**DRAFT FINAL INTERIM-ACTION, SUMMARY ALTERNATIVE SELECTION
REPORT, OPERABLE UNIT 2**

05/14/1993
HARDING LAWSON ASSOCIATES

**DRAFT FINAL
INTERIM-ACTION OPERABLE UNIT II
SUMMARY ALTERNATIVE SELECTION REPORT
NAVAL STATION TREASURE ISLAND
HUNTERS POINT ANNEX
SAN FRANCISCO, CALIFORNIA**

May 14, 1993

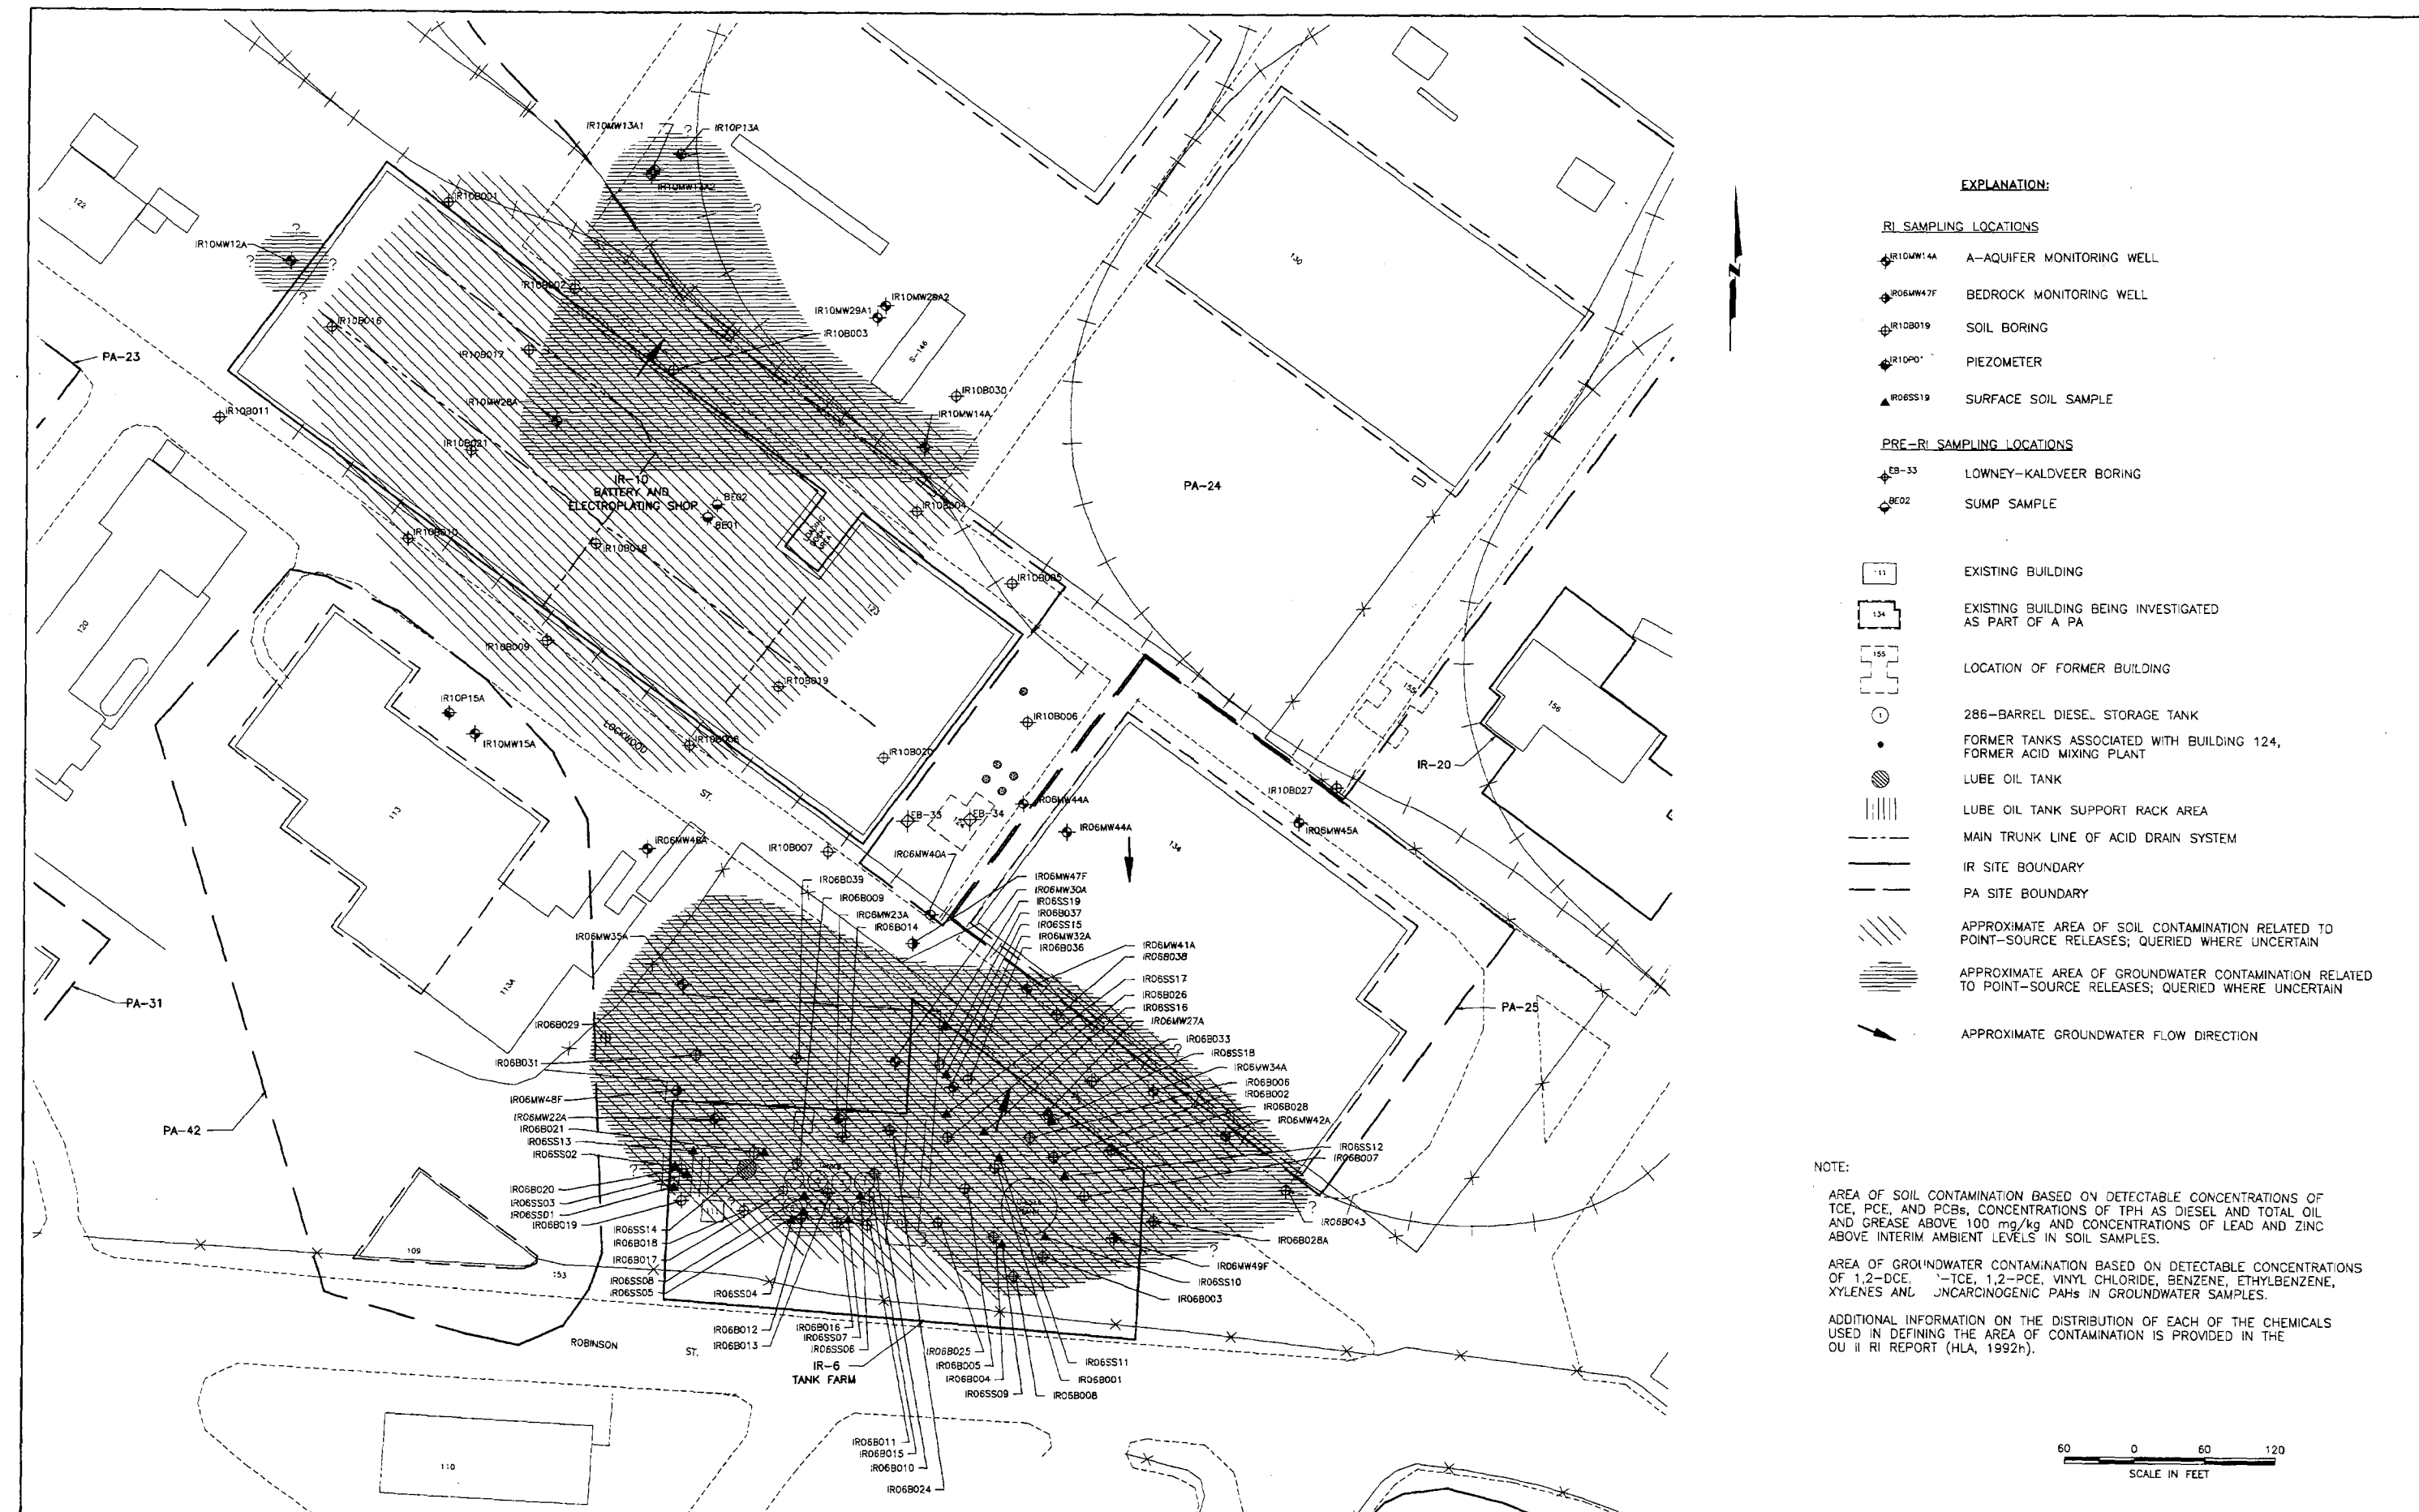
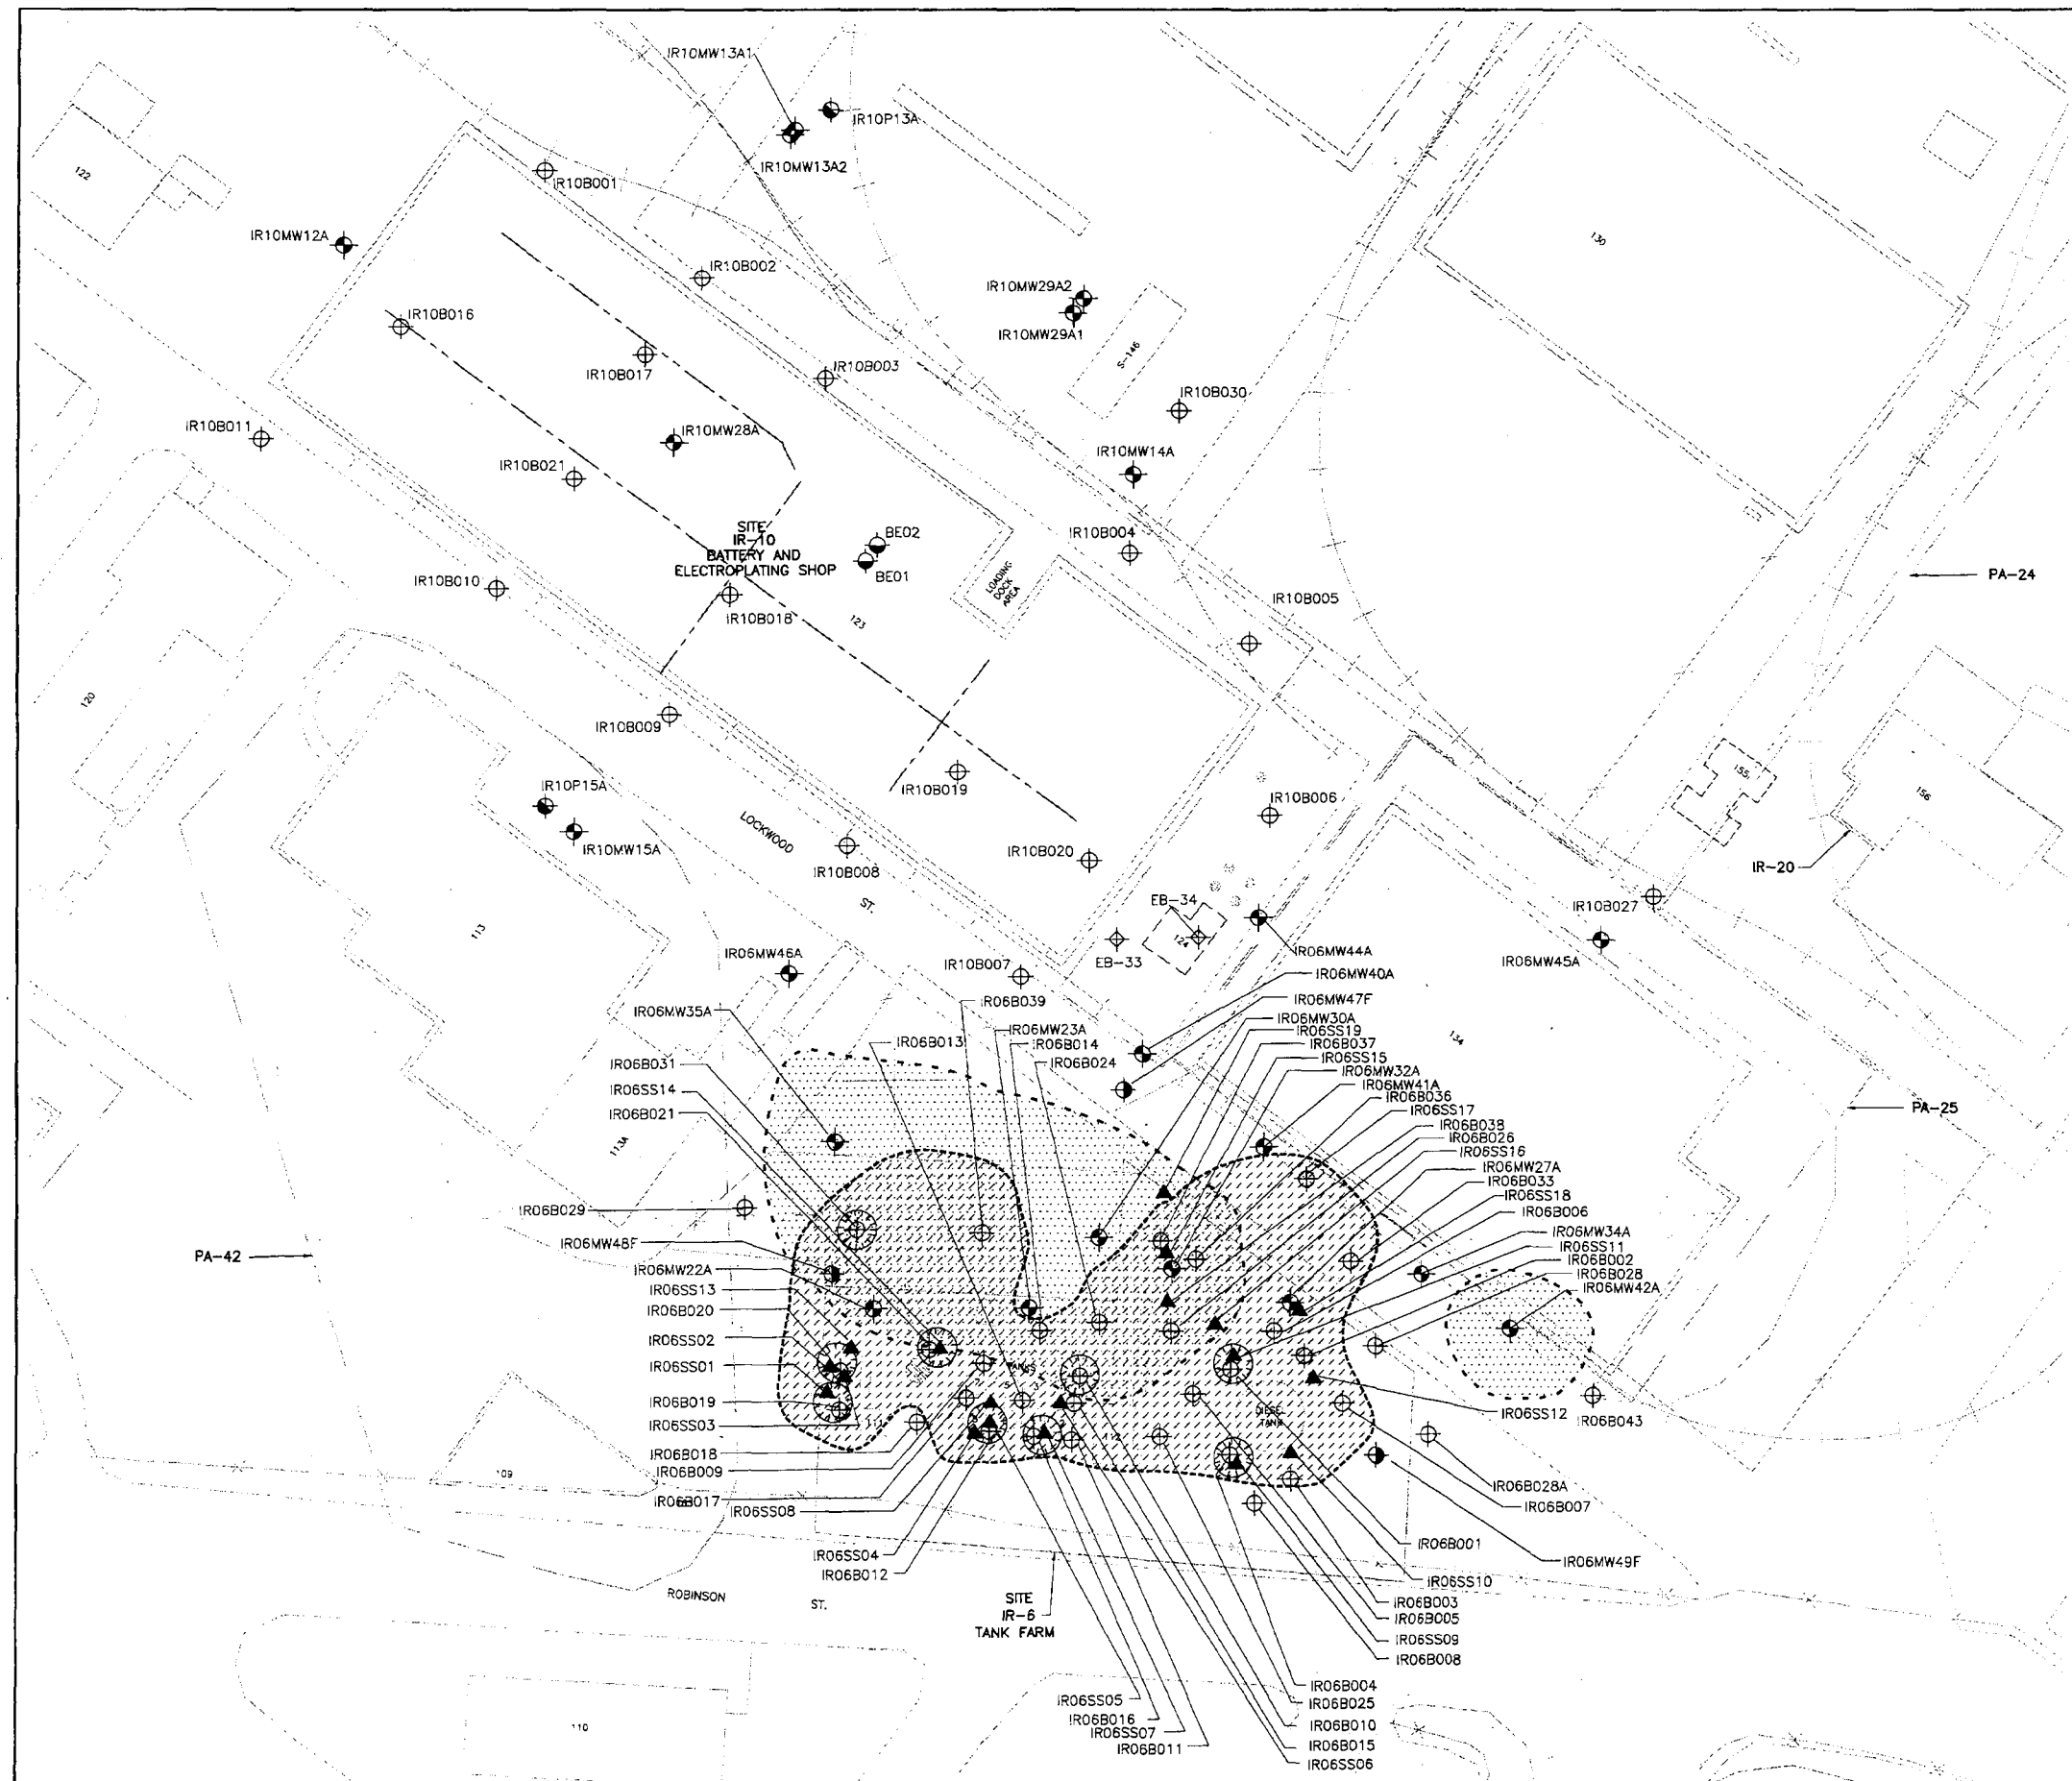
Comment 31: Plate 2-5; It is necessary to provide supporting documentation along with these plates. The following information should be provided at a minimum: 1) contaminant/s used to define the plumes or areas of

Response: Plates 2 through 5 have been revised to indicate the chemicals that were used to define the contaminated areas. Additional information on the distribution of individual point-source chemicals at the OU II sites is presented in the OU II RI Report.
